SUBJECT: Forwards revised pages to requested revision to DL. Reflects corporate organizational changes, revised audit frequency of security plan & appropriate Class II amend fee.

H. B. ROBINSON STEAM ELECTRIC PLANT, UNIT NO. 2
DOCKET NO. 50-261
LICENSE NO. DPR-23

REQUEST FOR LICENSE AMENDMENT - CORPORATE ORGANIZATION CHANGES

Figure 6.2-1
Effective June 1, 1979-August 31, 1979
6.2-3 Prime

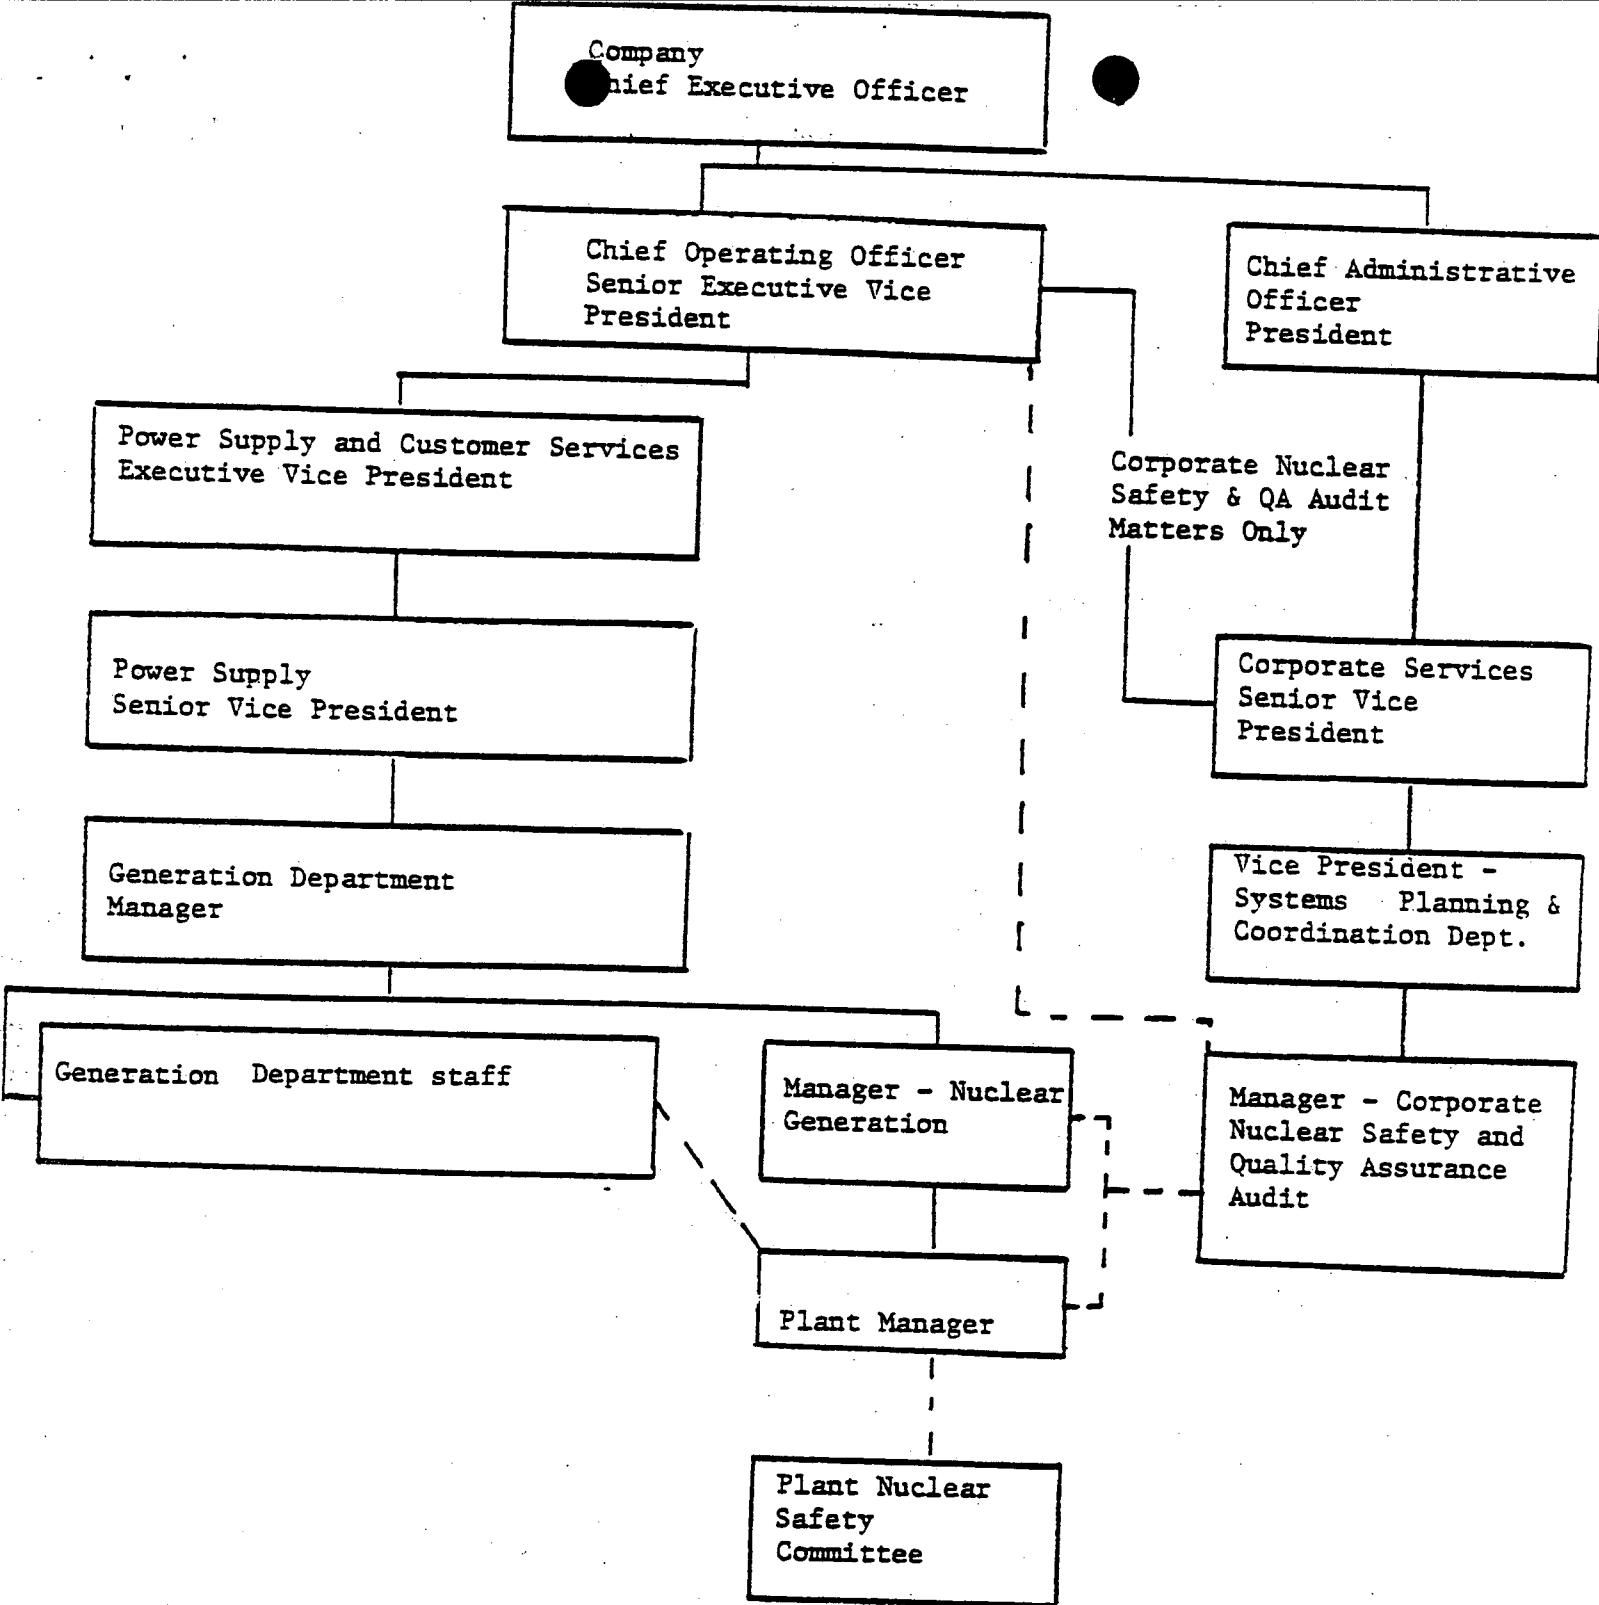
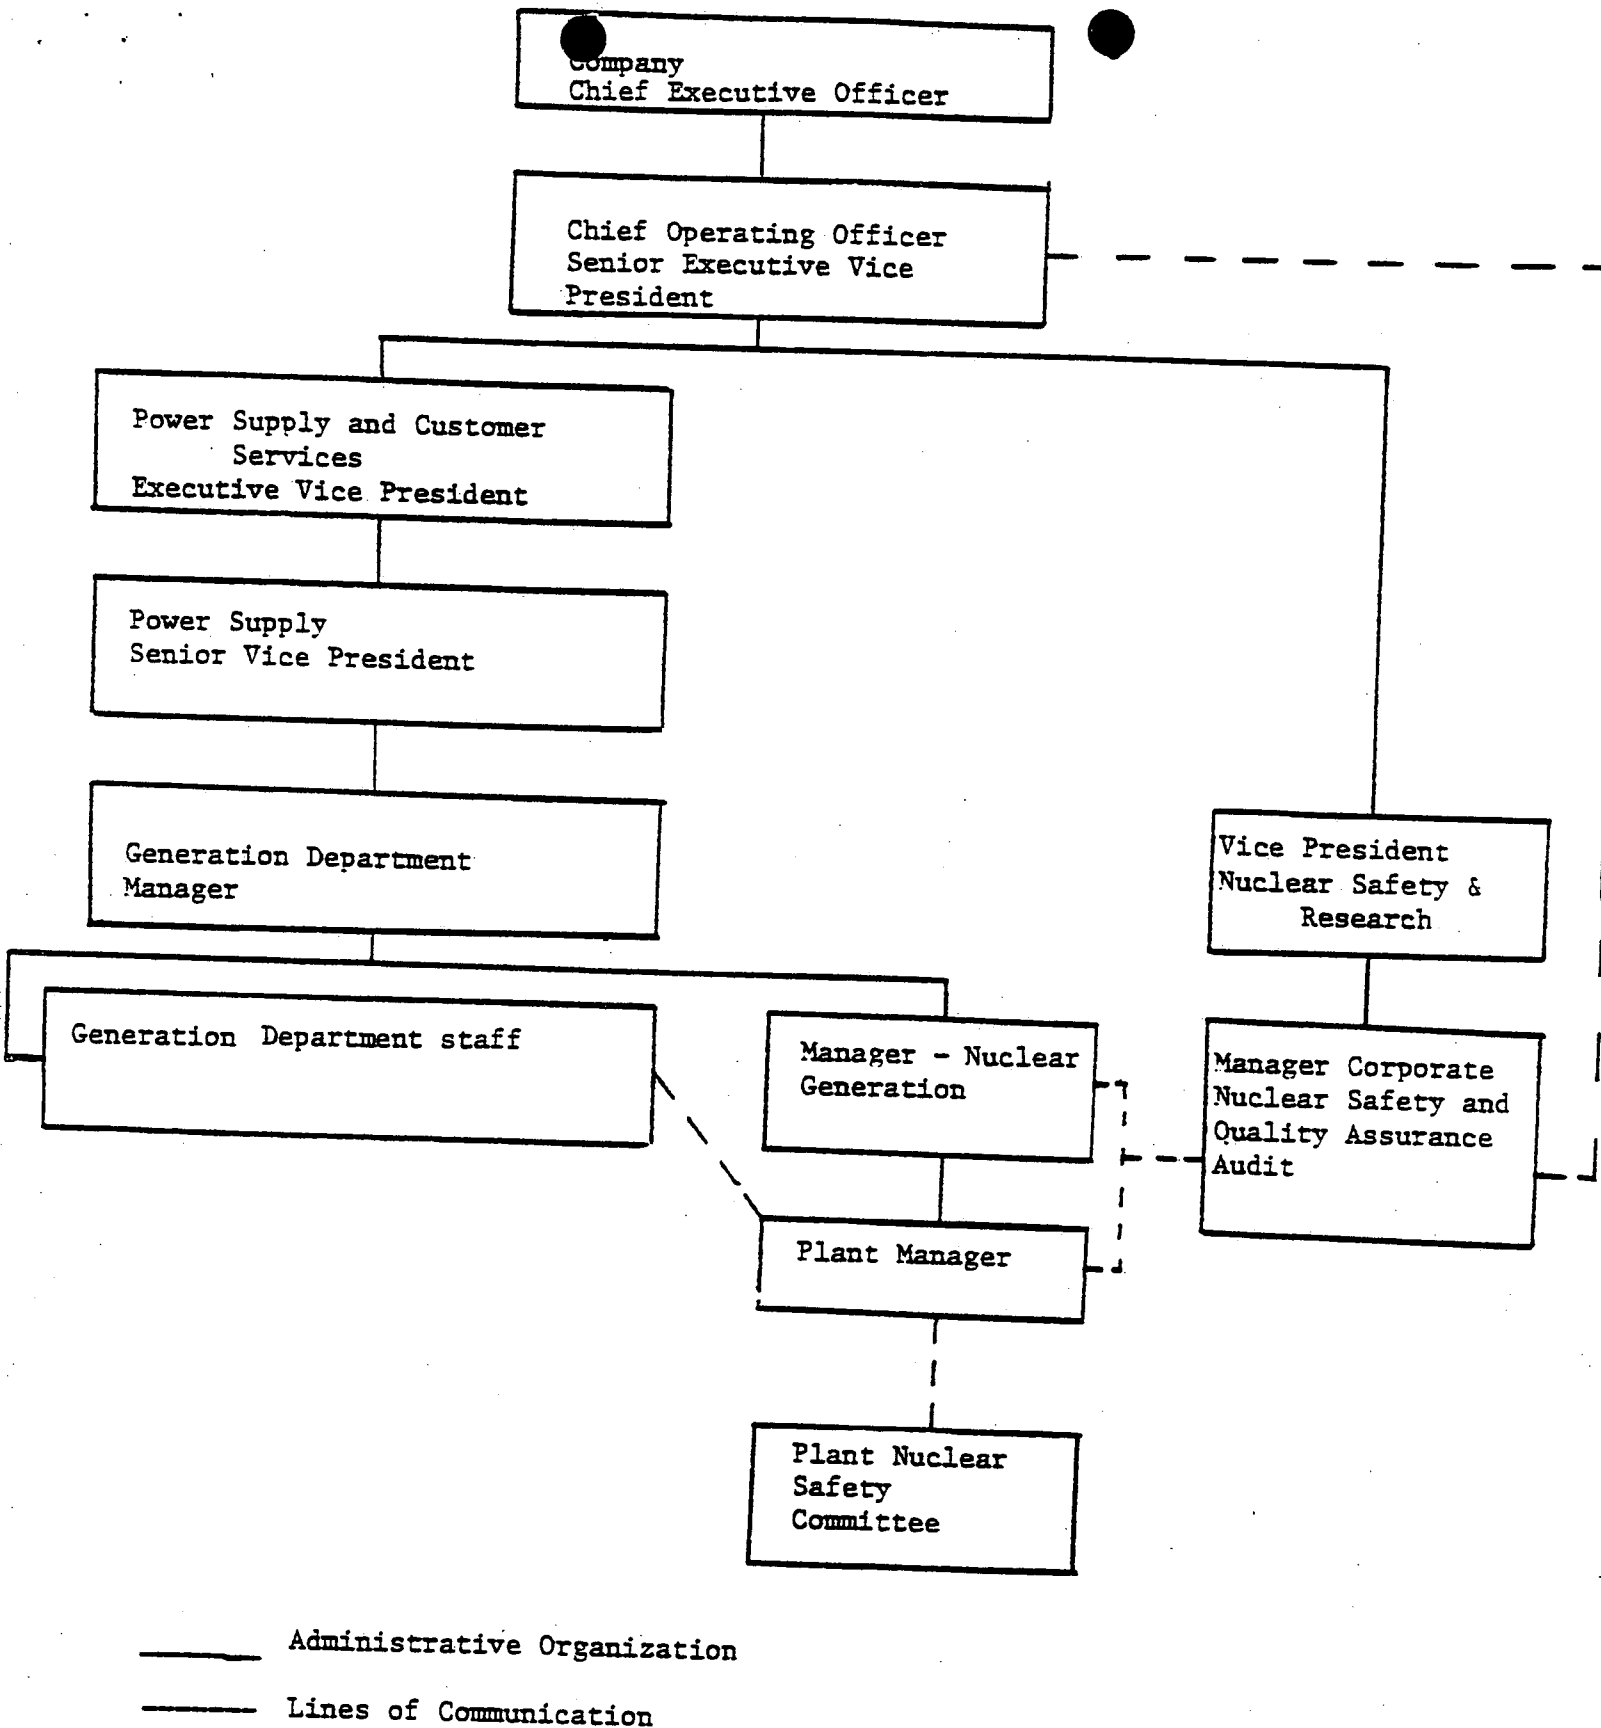
In accordance with the code of Federal Regulations, Title 10, Part 50.90 and Part 2.101, Carolina Power & Light Company (CP&L) hereby requests a revision to the Technical Specifications for its H. B. Robinson Steam Electric Plant, Unit No. 2. This change reflects corporate organization changes that took place June 1, 1979. Also, additional changes which will occur September 1, 1979 are included.

Enclosed are replacement pages for the H. B. Robinson Steam Electric Plant, Unit No. 2 Technical Specifications which reflect these revisions. Appropriate changes are indicated by the vertical lines in the right hand margin of the affected pages. It should be noted that some pages will only be effective through August 31, 1979. These pages are denoted by the word "prime" after the page number, and should be discarded on September 1, 1979.

Effective September 1, 1979, there will be a new Department of Nuclear Safety and Research, headed by Dr. T. S. Elleman. This new department will include the functions of Research, Health Physics and Corporate Nuclear Safety and Quality Assurance Audit.
